AS BUILT

INTERSTATE ROUTE H-1
ADDITION AND MODIFICATION OF FREEWAY ACCESS
(Kapolei Interchange Complex), Phase 2
Federal-Aid Project No. IM-H1-1 (261)

SHEET No. EA-15 OF 161 SHEETS

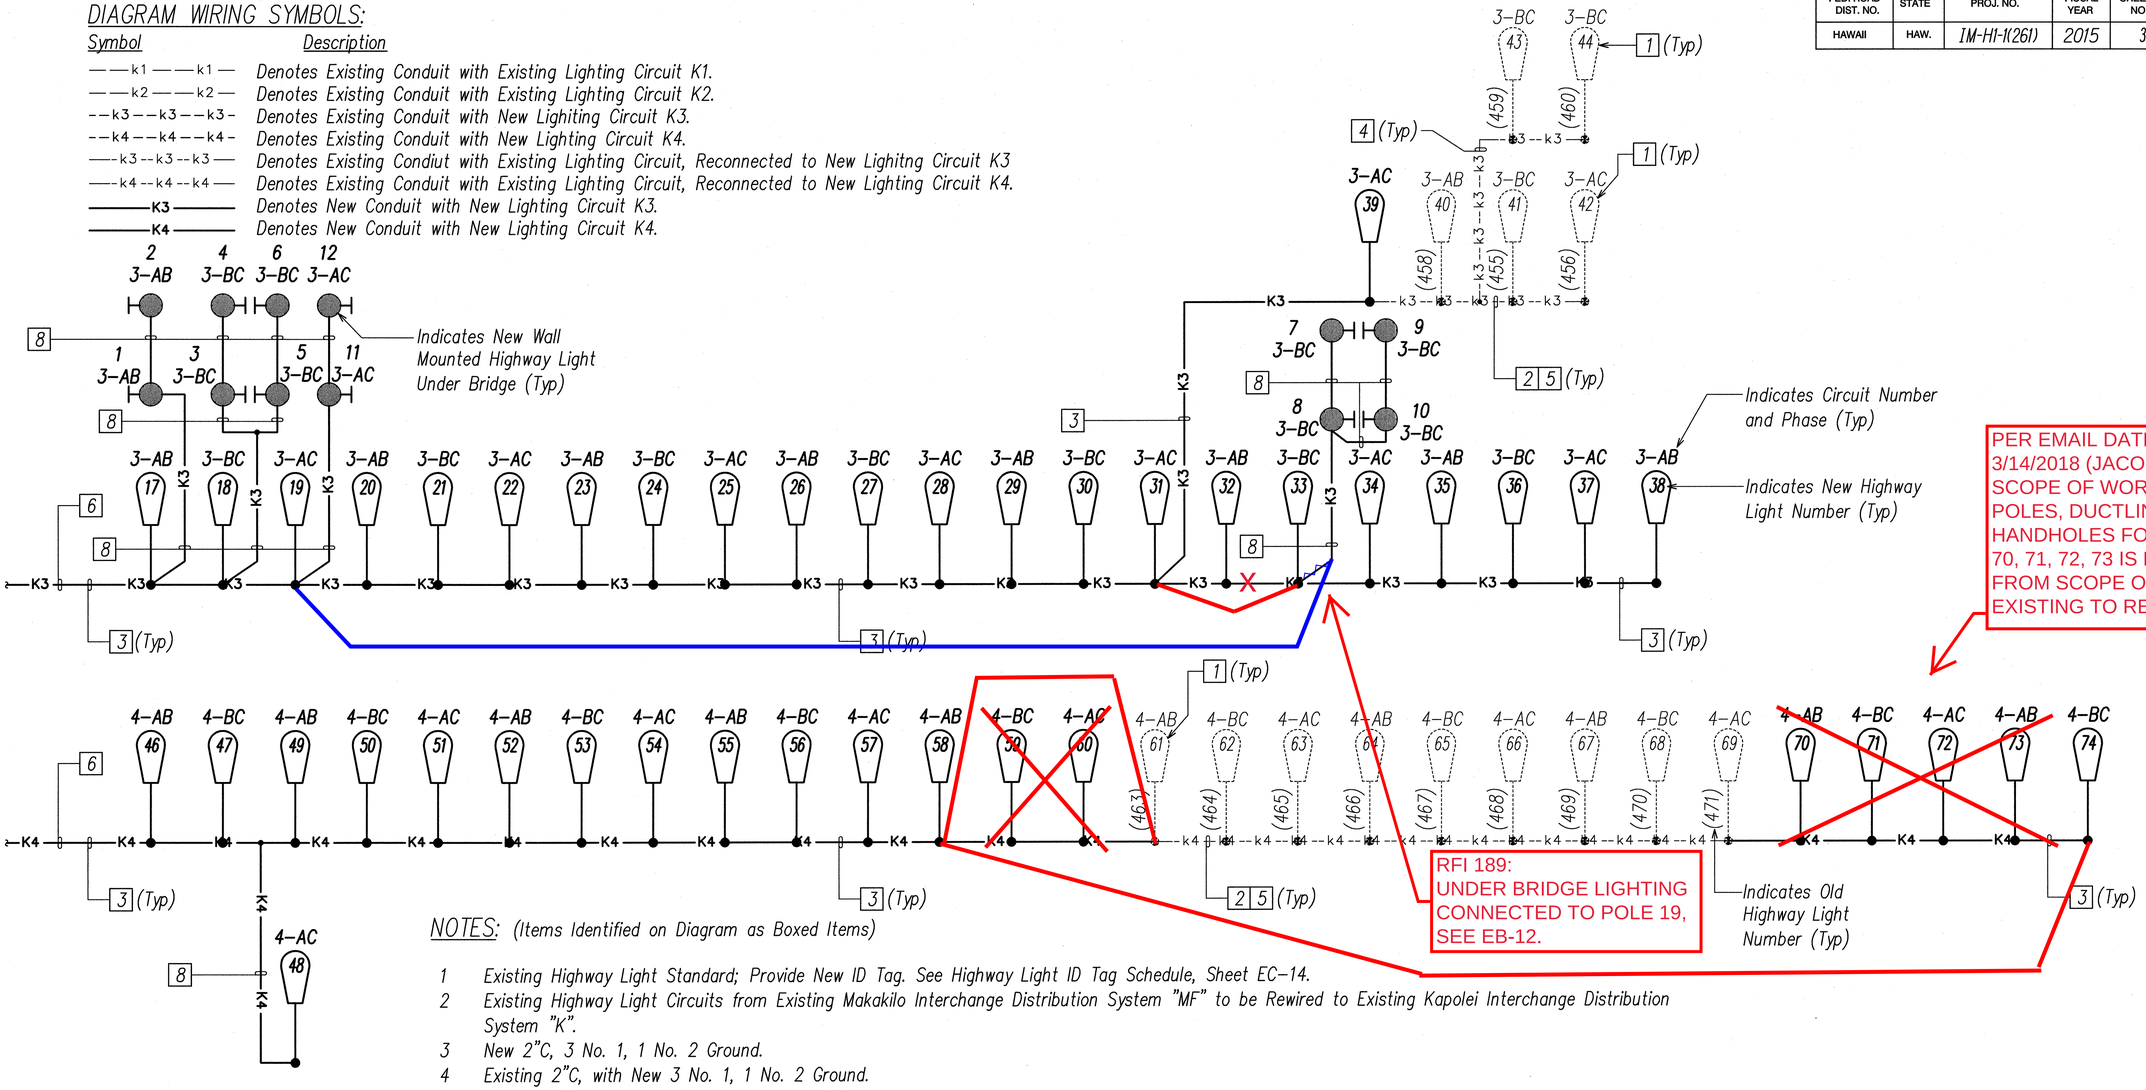
PER EMAIL DATED 3/14/2018 (JACOB PLAN): SCOPE OF WORK FOR POLES, DUCTLINE, AND HANDHOLES FOR POLES 70, 71, 72, 73 IS DELETED FROM SCOPE OF WORK; EXISTING TO REMAIN.

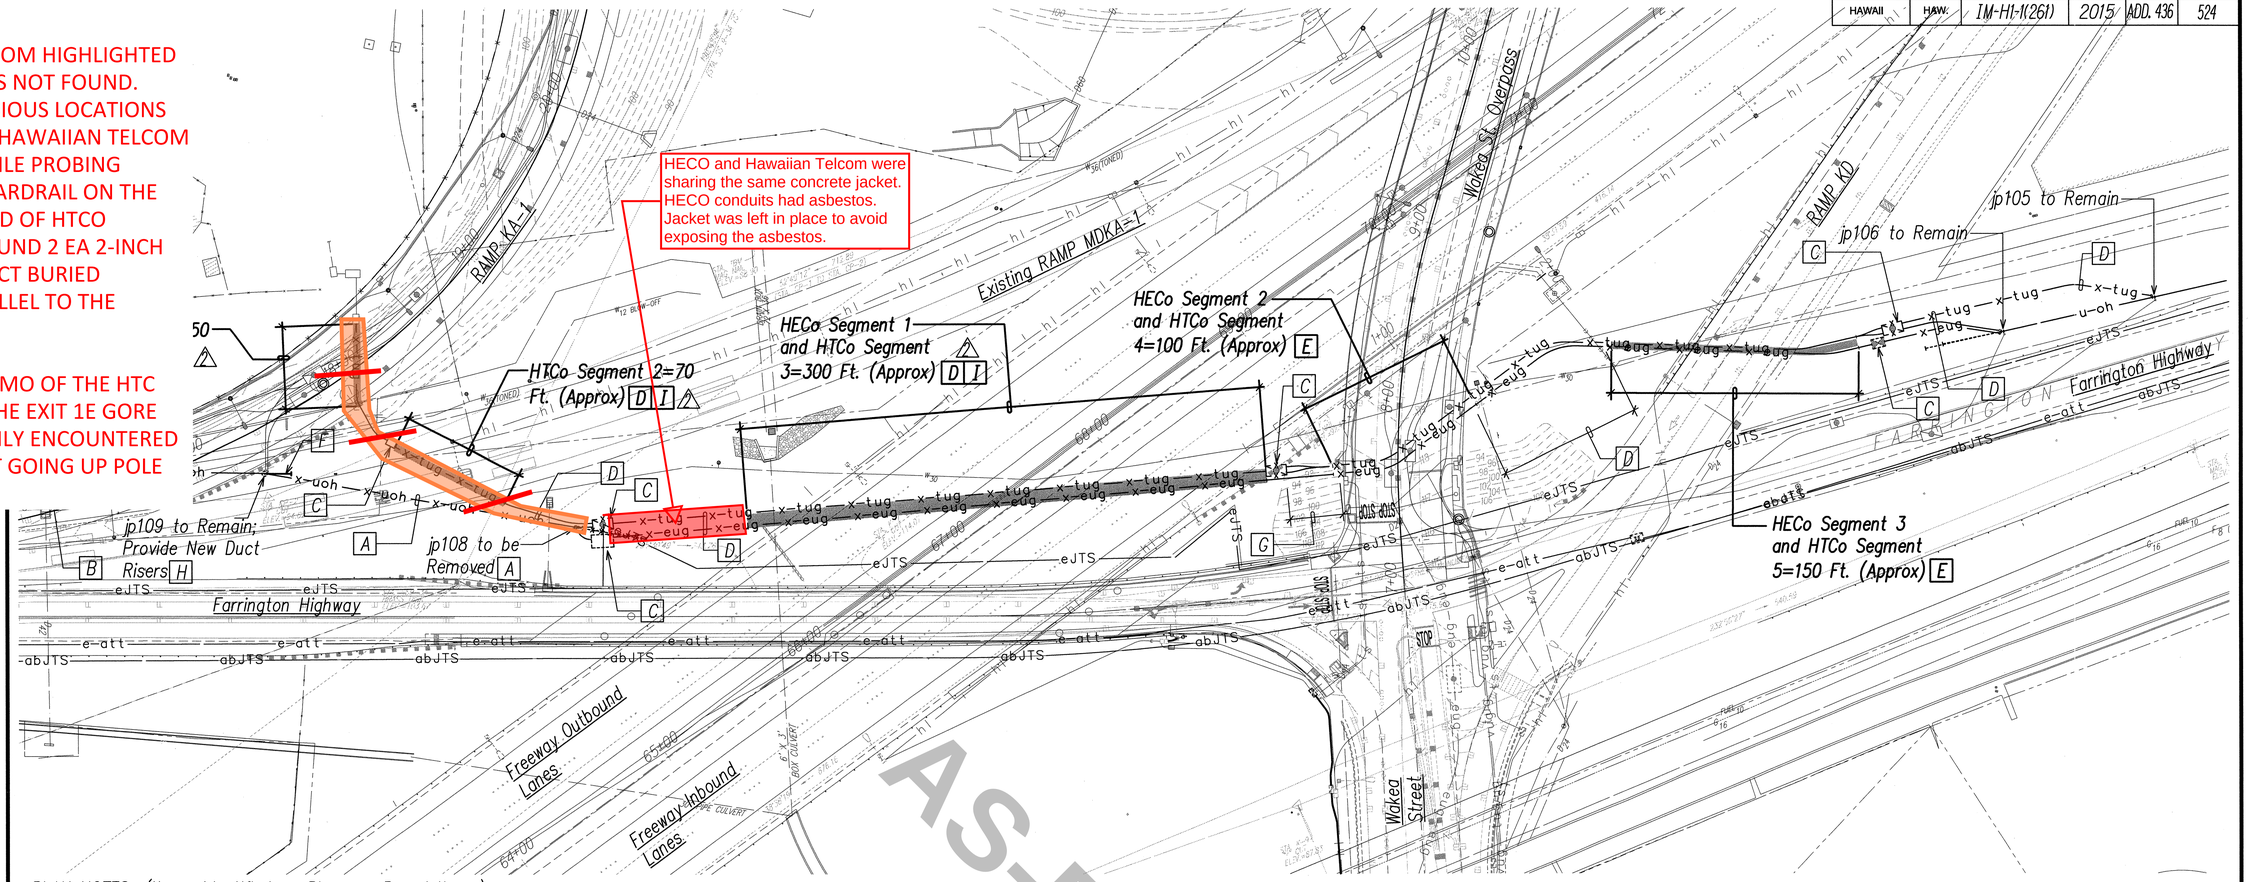
HAWAIIAN TELCOM HIGHLIGHTED IN ORANGE WAS NOT FOUND. PROBED AT VARIOUS LOCATIONS ALONG WHERE HAWAIIAN TELCOM IS SHOWN. WHILE PROBING ALONG THE GUARDRAIL ON THE WET N WILD END OF HTCO SEGMENT 2, FOUND 2 EA 2-INCH CONDUITS DIRECT BURIED RUNNING PARALLEL TO THE GUARDRAIL.

DURING THE DEMO OF THE HTC MANHOLE AT THE EXIT 1E GORE AREA, CREW ONLY ENCOUNTERED THE HTC JACKET GOING UP POLE NO. JP108
